PLAN COMMISSION MEETING AGENDA

**Wisconsin Granite Depot
6720 S. 27th Street
Tax Key No. 737-9038**

Plan Commission Report

PROJECT: Plan Review – Pasa Ece, Wisconsin Granite Depot

Project No. 1311500
Sheet No. T1
Of 6 Sheets

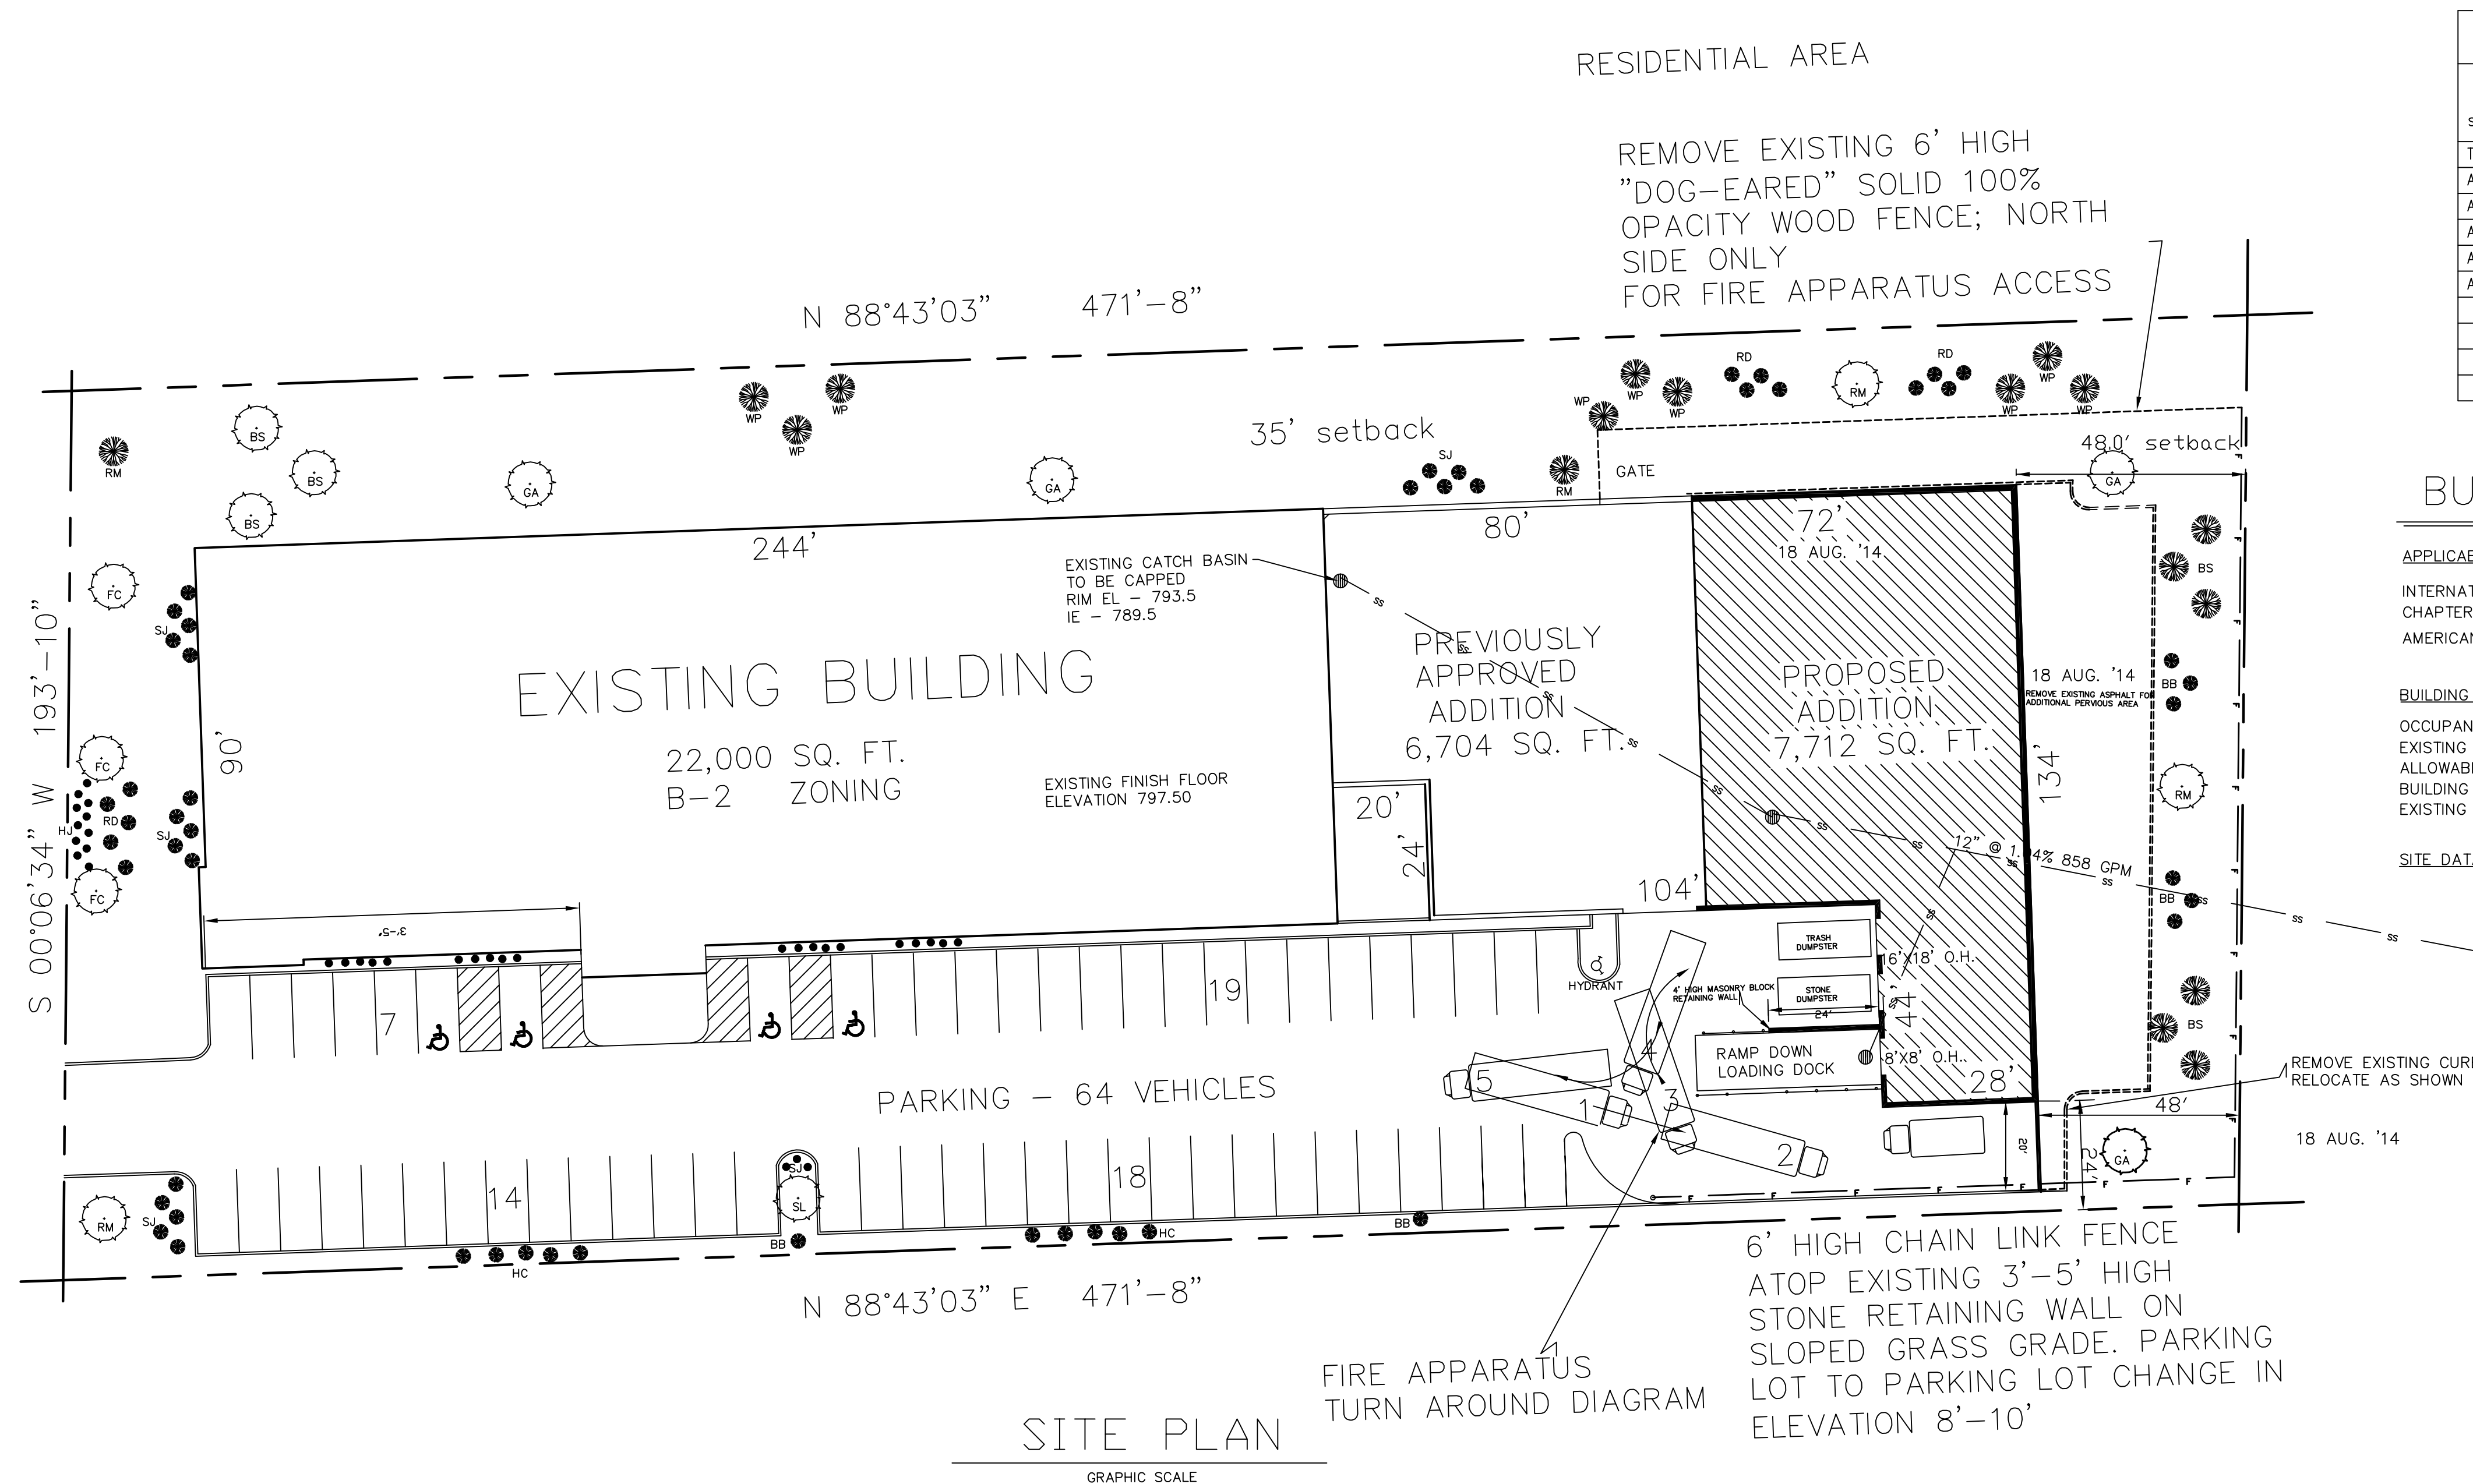
Ms. Papelbon described the proposed plans, noting that there was a paved area extension included in the Plan Commission packet that has since been removed. The area which is currently paved now shows some pervious area restored. Although it does say there are stalls for 64 vehicles, 58 stalls are shown.

Mayor Scaffidi confirmed that the first approved addition of 6,704 square feet was not constructed yet, and the applicant is asking for a second addition of 7,712 square feet, which calls into the question the number of parking spots that are available on the site. There are also screening issues with the loading dock. Mayor Scaffidi asked if the applicant was aware of these issues. Representatives confirmed that they were.

Ms. Papelbon stated that she spoke with the City's Environmental Engineer and he calculated the green space versus lot coverage and came up with, at most, just about 30%. Based on what the original plans were (showing less than 30%) and the estimates, they just barely met the requirements. There were some questions about that, and it was the City's Environmental

Engineer who stated that there was not 33% green space on the lot. Mr. Sharpe responded that the total land area is 91,396.08 square feet, the proposed building area is 36,416 square feet, and 39.84% lot coverage. There is 54,980 square feet of open space. The paved area came out to 24,720 square feet, which comes out to a pervious area of 30,260 square feet or 33.1%. Ms. Papelbon stated that there would have to be some discussions to get the correct number.

Mr. Sharpe stated that they had a requirement before to have 50% opacity screening facing the Menard's parking lot. To have a loading dock there is like seeing one of their trucks coming around the building. He does not see the need for that screening to be constructed of a similar material as the building and 100% opacity. Ms. Papelbon clarified that based on the Code, the screening is to be fully opaque landscaping or a wall to match the building.

Asst. Fire Chief Kressuk stated that even the current setup is not good for a turnaround. He stated that they are in the process of coming up with a reasonable solution. One of the Fire Department's concerns for fire risk is having access around the east side of the building to reach those vehicles. Moving the dock into that one-way lane creates a new dynamic. When you reach a certain length of a one-way access road, you have to have a Fire Department-approved turnaround. Currently there is no good way to do this. The solution currently under discussion involves a Y-turn around a loading dock. The architect is aware that this is a work in progress, and there might be some adjustment to the parking islands which will affect parking spaces. The southernmost island is a turn they may ask to have removed just for access for the turnaround.

Mr. Kressuk stated that the owner should be aware that the loading docks, except for the drive down loading dock, must remain clear because they are turnaround areas. Because the buildings are fully sprinklered, they can be further away from access roads. The north side of that structure creates some issues. The architect is aware that an additional fire hydrant and sidewalks may be required.

Although setback requirements are fulfilled with the proposed location of the addition, the Regional Retail Overlay District requires loading docks to be fully screened from adjoining properties through the use of fully opaque landscaping and/or a wall matching the building. The Code does not allow screening through the use of gates or fencing. The locations of the proposed loading docks may be viewed from the property to the south as a chain link fence with 50% opacity slats exists along the southern property line.

Parking on this lot is severely restricted with the proposal. During the September 23, 2013 review of the application for a fence on the property, the Plan Commission approved a reduction in the minimum parking requirement, and required a minimum of 59 stalls to remain available for parking. This was acceptable as an area was set aside for 11 future parking stalls on the northeast portion of the property at the May 23, 2000 meeting as part of the review for the original building, and there was sufficient space for additional parking on the east. At the January 14, 2014 meeting, the Plan Commission approved the construction of the 6,704 square-foot addition onto the east of the existing building. No change to the existing parking was proposed and there was still sufficient space for future parking stalls on the east. For reference, this would have required an additional 45 parking stalls according to Section 17.0403(j)(2).

In the current proposal, the number of parking stalls is being reduced to 58 with no possibility for future parking on the property. With an addition of this size, the Code requires "one (1) space per 5,000 square feet of gross floor area, plus one (1) space per employee for the work shift with the largest number of employees." Therefore, at least 16 new parking stalls would be required based on the size of the space, and assuming 14 employees onsite at any given time.

Additionally, site plans must include space set aside for future parking areas in full compliance with Code requirements. If granted by the Plan Commission, this would be the third reduction in the minimum parking requirements. Staff has concerns for the limited number of parking stalls proposed and the fact that the addition leaves no room for future parking areas. There is no capacity for further expansion of the building or parking to meet Code requirements, and the lot currently does not meet the minimum 30% open space requirement. Therefore, staff recommends that the Plan Commission does not approve of the proposed addition.

1. That all figures and calculations are based on the parcel size of 2.088 acres.
2. That a minimum of 30% open space as defined in Section 17.1009(a)(21) is maintained on the property. Revised plans showing this open space requirement shall be submitted to the Department of Community Development prior to submission of building permit applications.

3. That a minimum of fifty-eight (58) parking stalls are maintained on the property. (This figure may change due to Fire Code requirements).
4. That all technical corrections (correct address, number of parking stalls, acreage, etc.) are made and submitted to the Department of Community Development prior to submission of building permit applications.

5. That landscaping plans are submitted for review and approval by the Department of Community Development prior to issuance of permits. These plans must include fully opaque landscaping and/or a wall matching the building to screen the loading docks on the south side of the property.

6. That all building and fire codes, including required emergency vehicle turnarounds, are met. All emergency vehicle turnarounds shall be depicted on the revised plans and submitted to the Department of Community Development prior to submission of building permit applications.
